RE: **Grants Reclamation Project – DP-200 Renewal – Response to September 12, 2000 NMED Letter Transmitting Comments / Questions on Renewal Application**

**HOMESTAKE MINING COMPANY
Grants Reclamation Project
DP-200 Renewal**

**RESPONSES TO
NEW MEXICO ENVIRONMENT DEPARTMENT
REGARDING QUESTIONS / COMMENTS ON DP-200
RENEWAL APPLICATION
PER
NMED LETTER DATED SEPTEMBER 12, 2000**

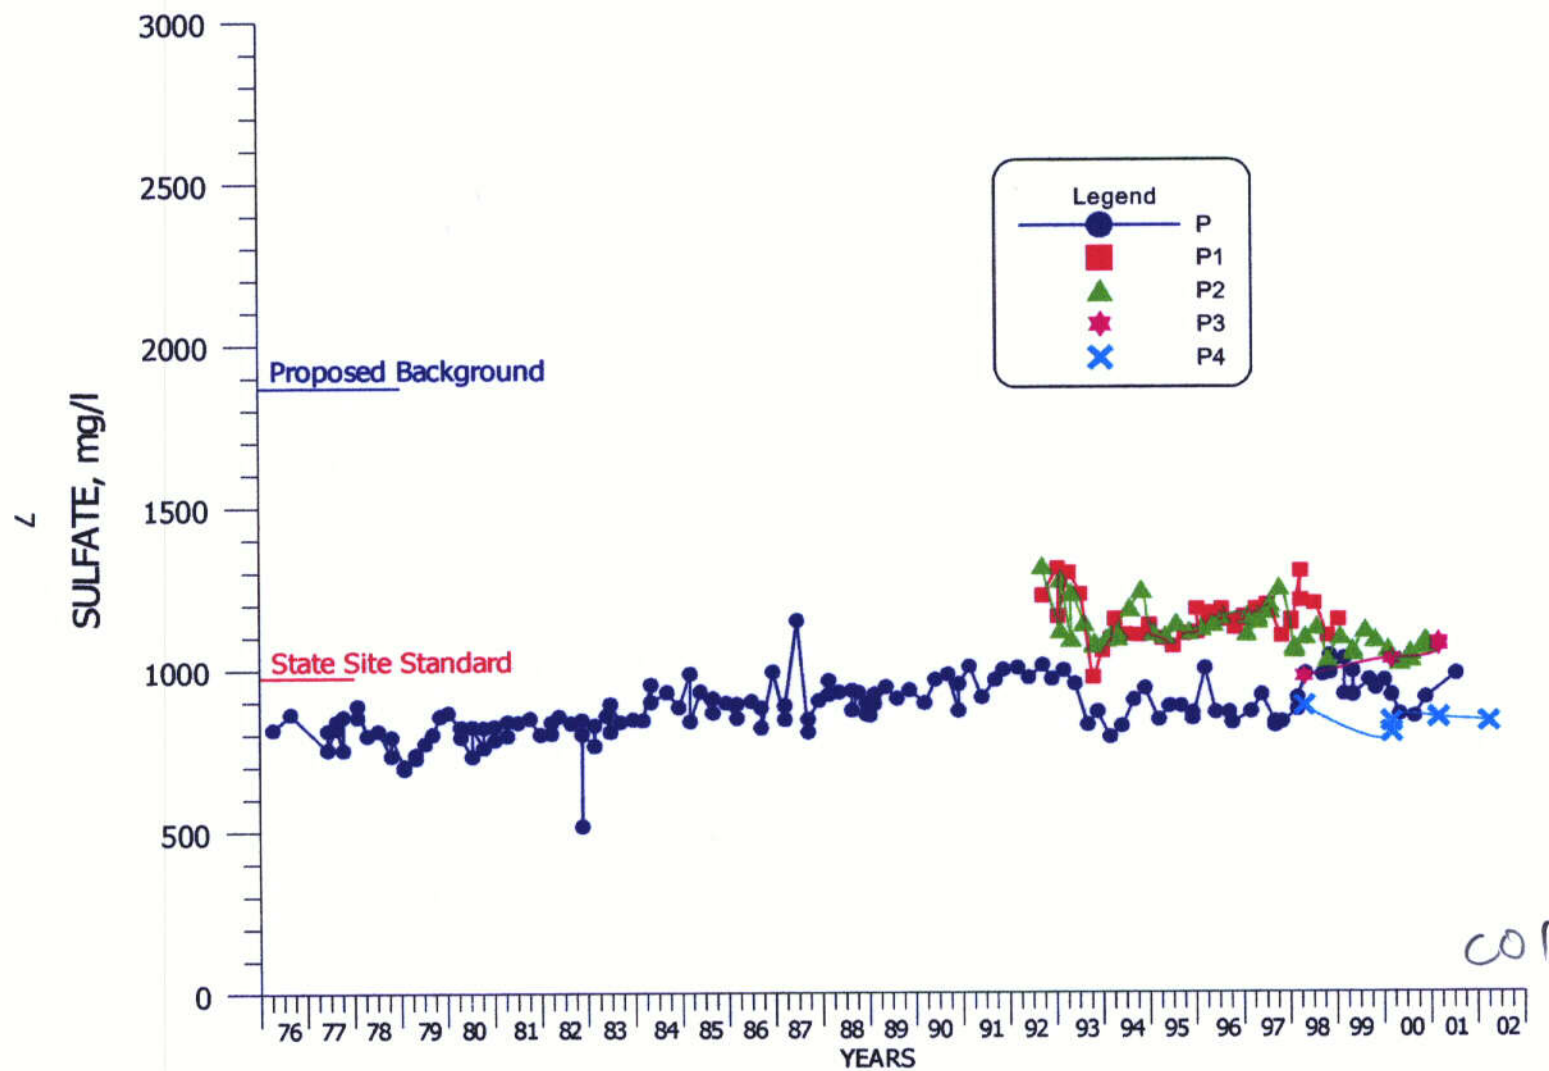
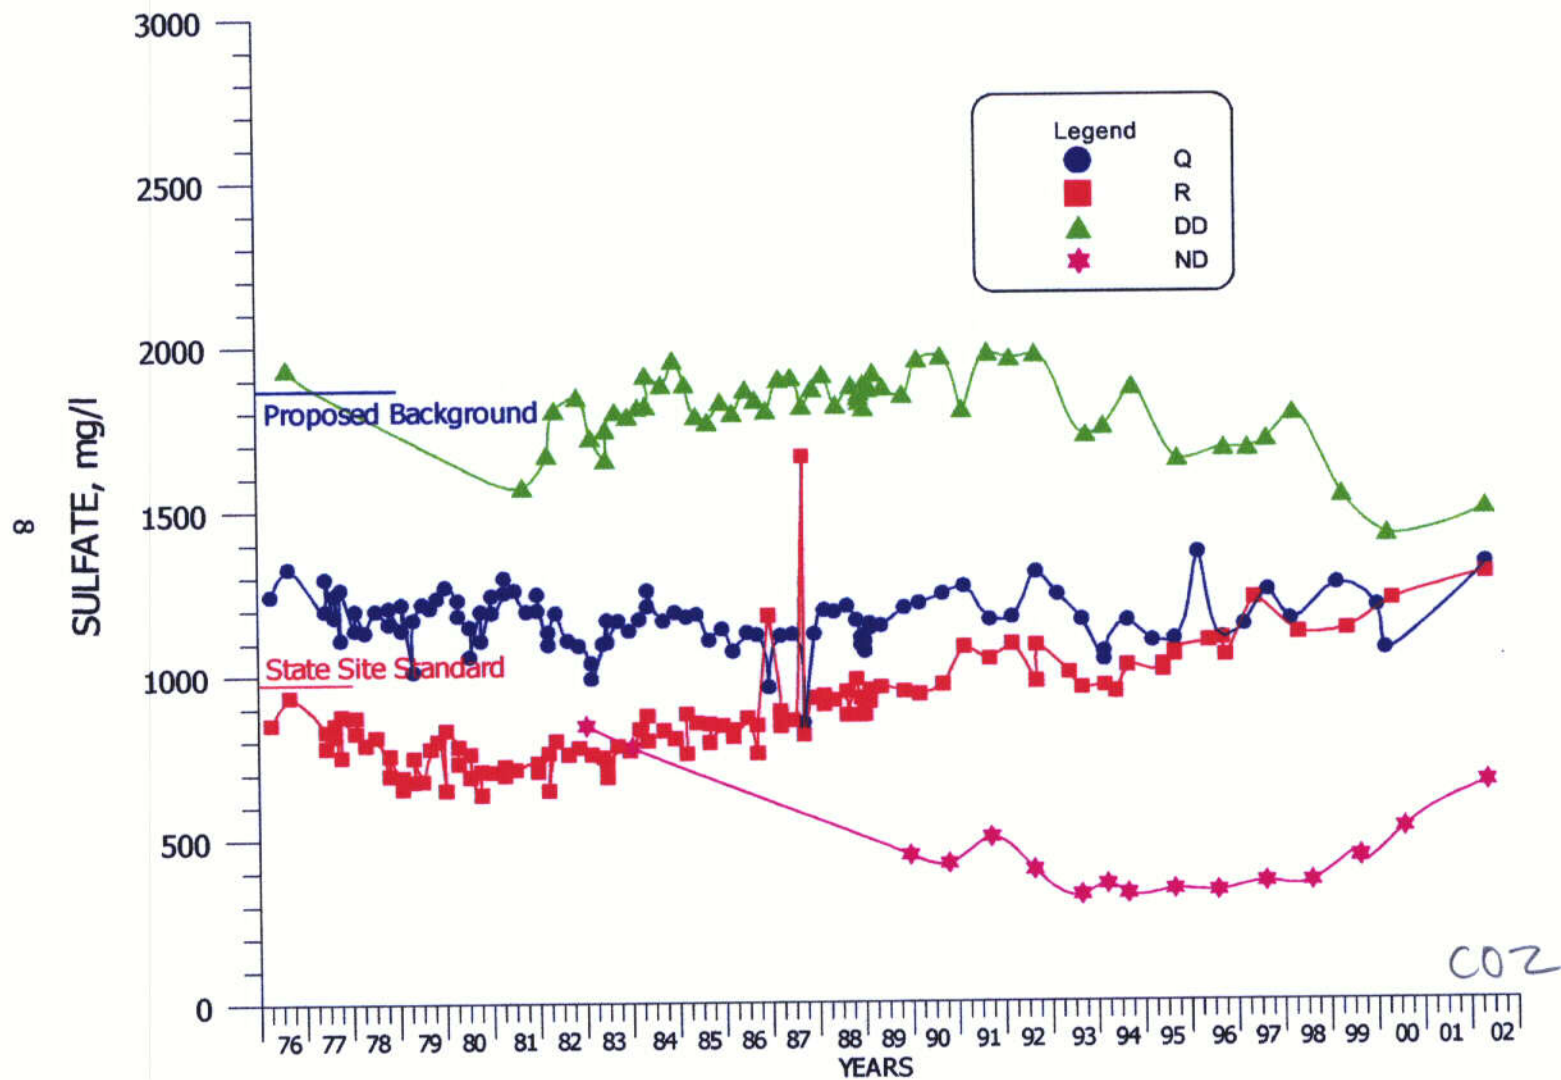
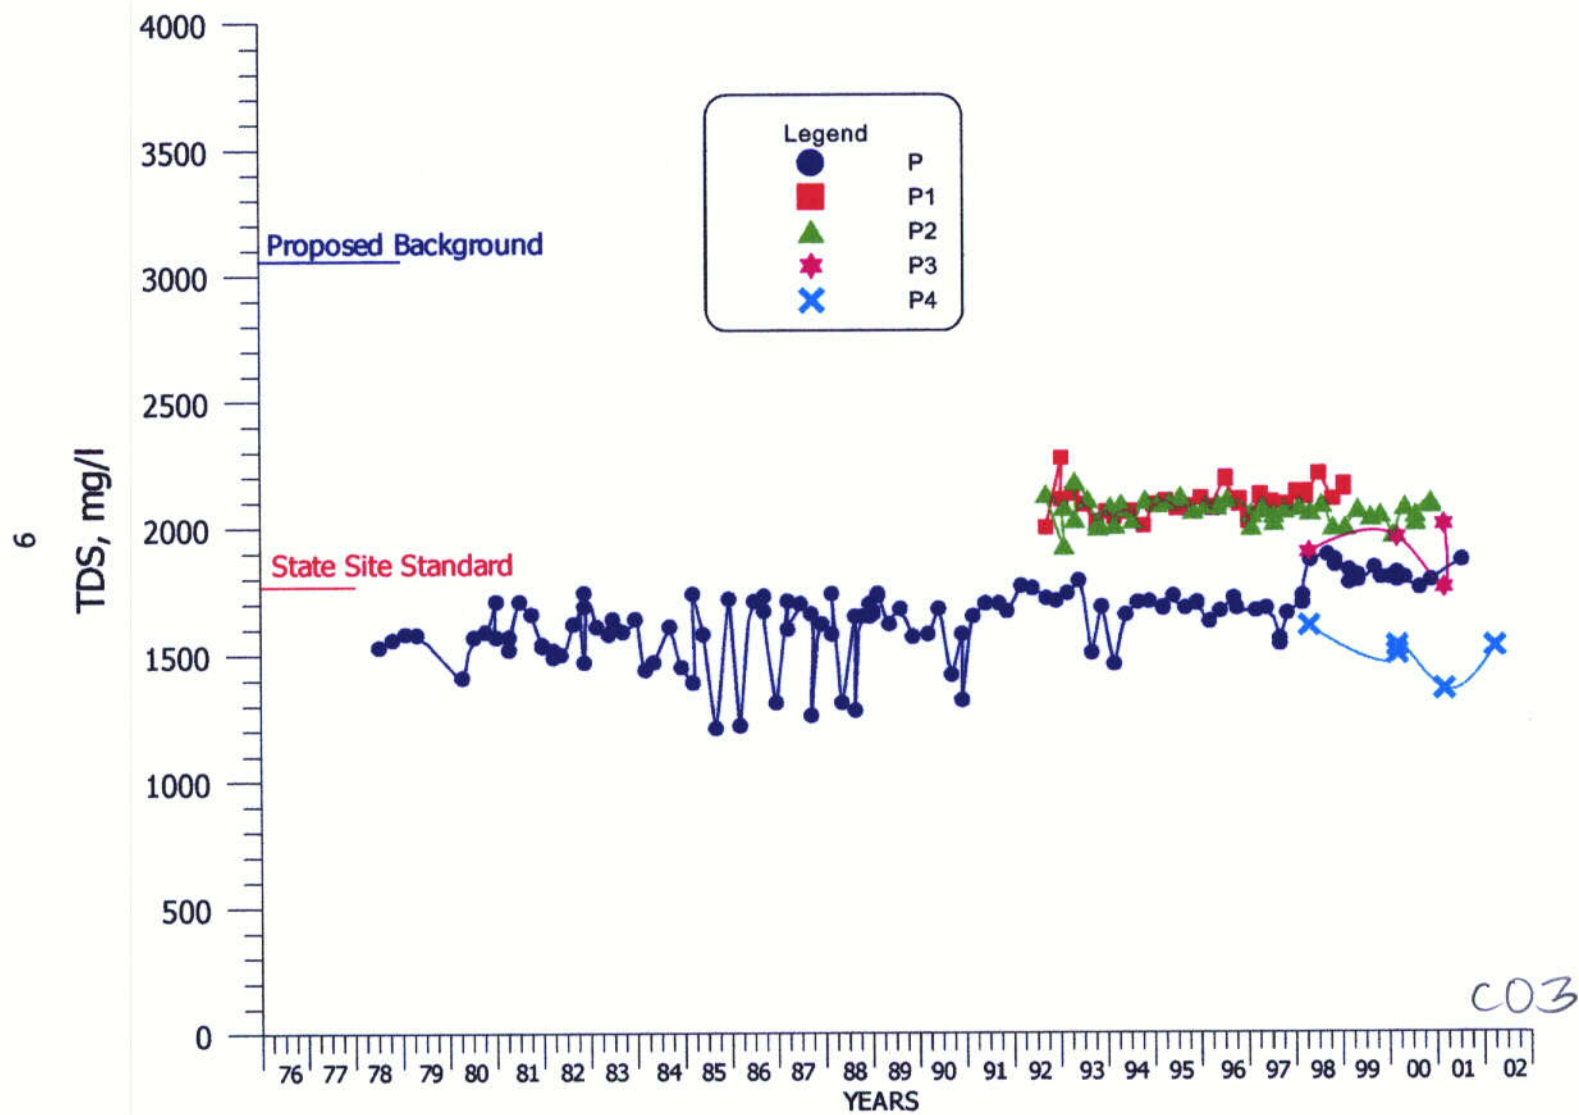
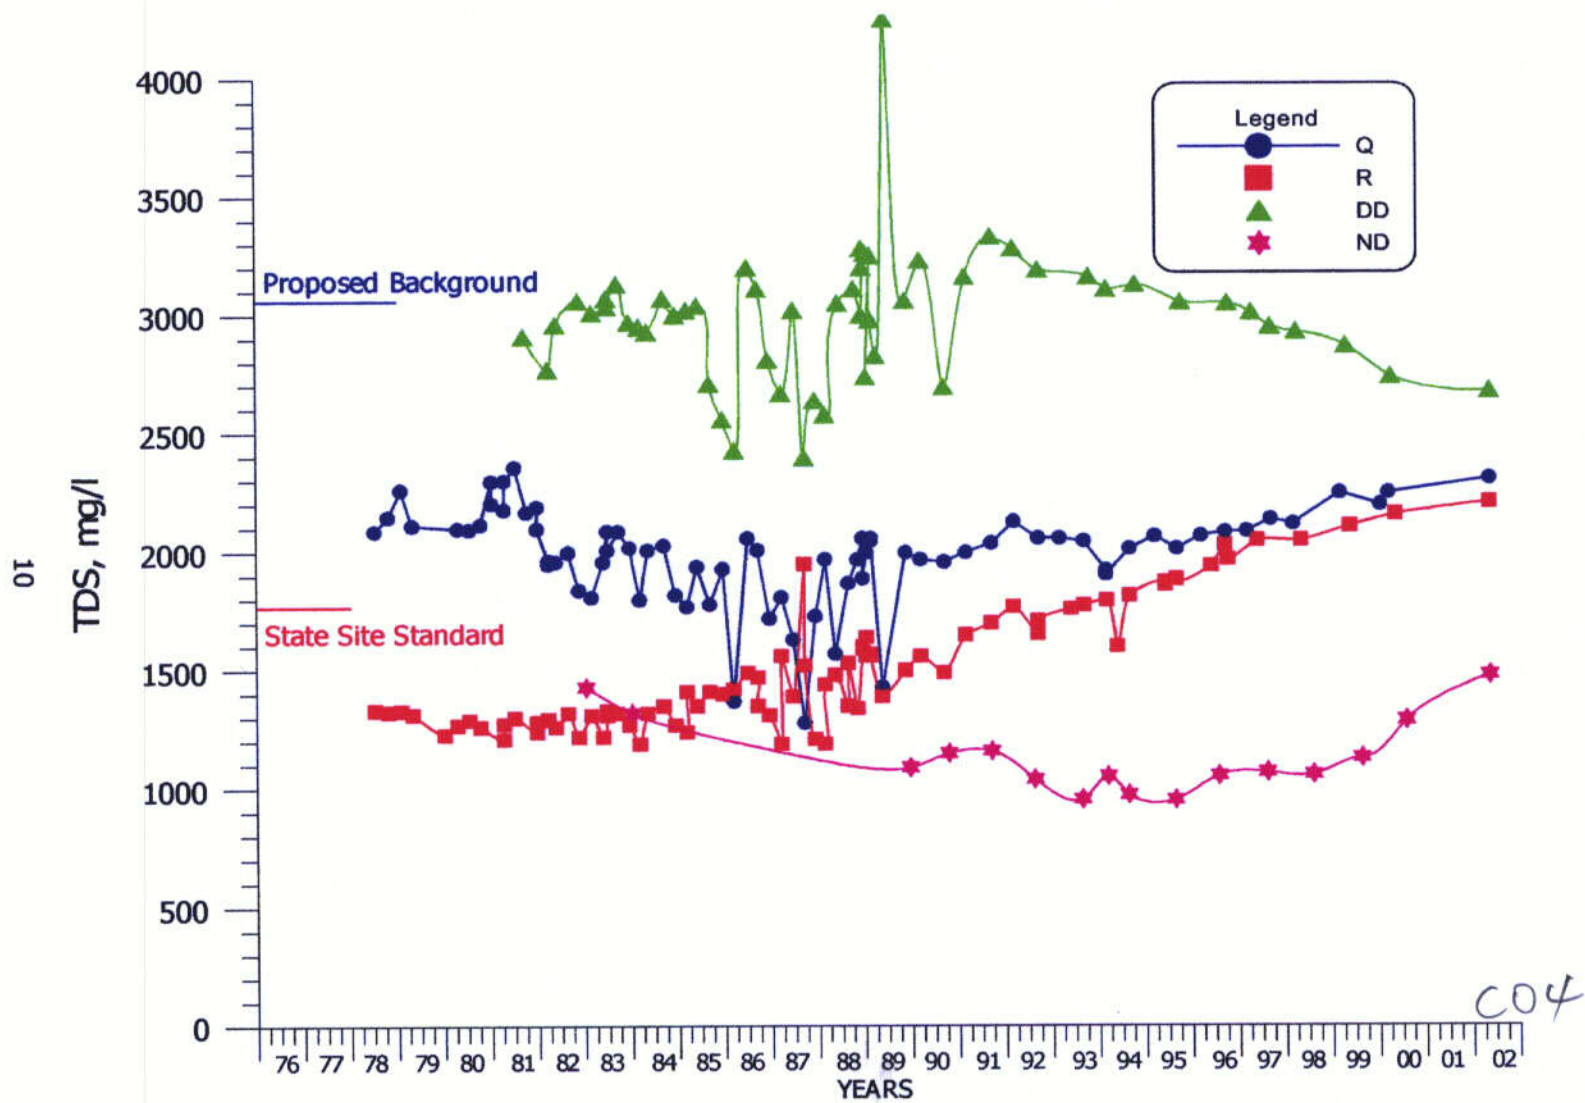
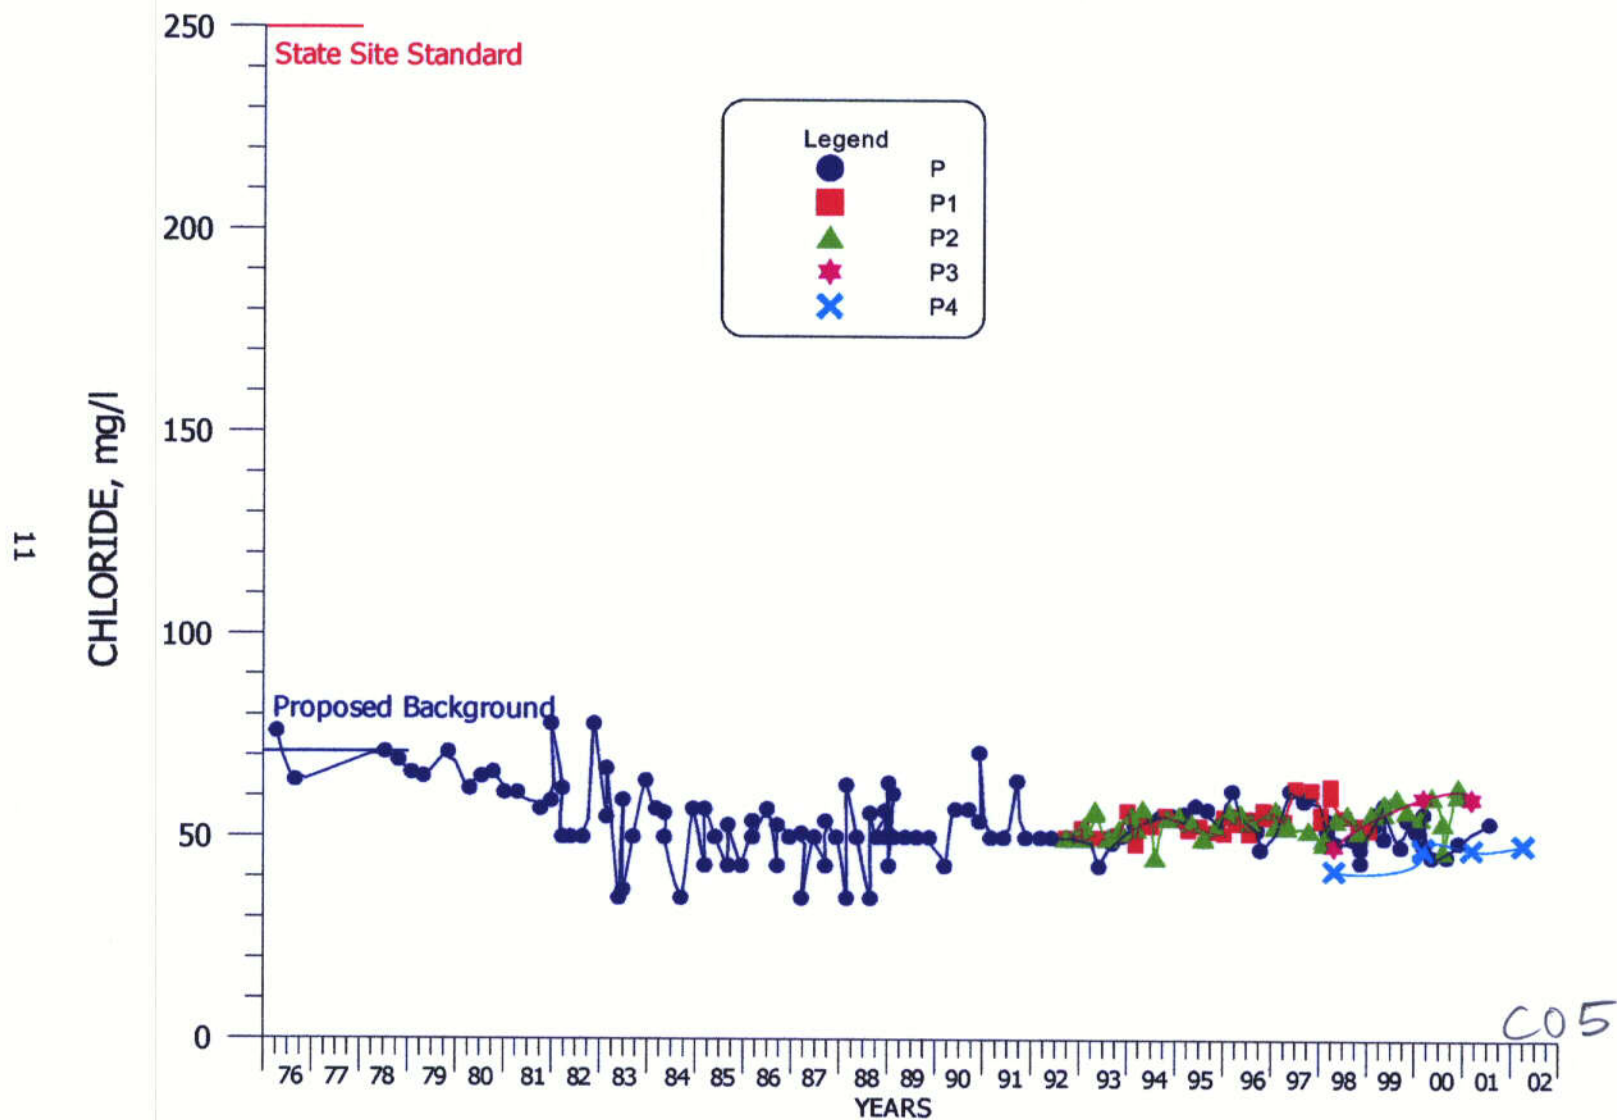
Comment: II.4. Water Quality Trends in Near Upgradient Wells

Comment: II.5.A. Graphs for Near Upgradient Data

Response: Plots of historical water quality for TDS, chloride, uranium, selenium, molybdenum and nitrate were developed for wells P, Q, R, DD, ND, P1, P2, P3 and P4 at the same vertical and time scales. The 5 'P' wells are grouped together because they are in the same vicinity of the alluvial aquifer. The remaining four background wells, which are west, north and east of the 'P' wells, are shown on the second plots. The historical plots of water-quality concentrations for the 9 background wells are presented in the enclosed figures according to the following list:

Constituent	FIGURE NUMBER	
	P Wells	Non-P wells
SO4	1	2
TDS	3	4
Cl	5	6
U	7	8
Se	9	10
Mo	11	12
NO3	13	14

The present State site standard was determined from the mean concentrations for upgradient wells P, Q and R for data from 1976 through early 1983. These mean concentrations are presented in Table 2 of the NMED's Pre-hearing Ground-water Discharge Plan Analysis for the Homestake Uranium Mill near Milan, New Mexico, published in January 1984. The use of the mean concentrations does not define the upper portion of the natural background concentrations. Also, the much shorter record does not account for the historical changes that have been observed over the last 24 years. The additional near background wells also better define the natural areal variation in the alluvial aquifer. Therefore, the present statistical analysis of full background is a much more appropriate way to define the site standards at the Grants site.
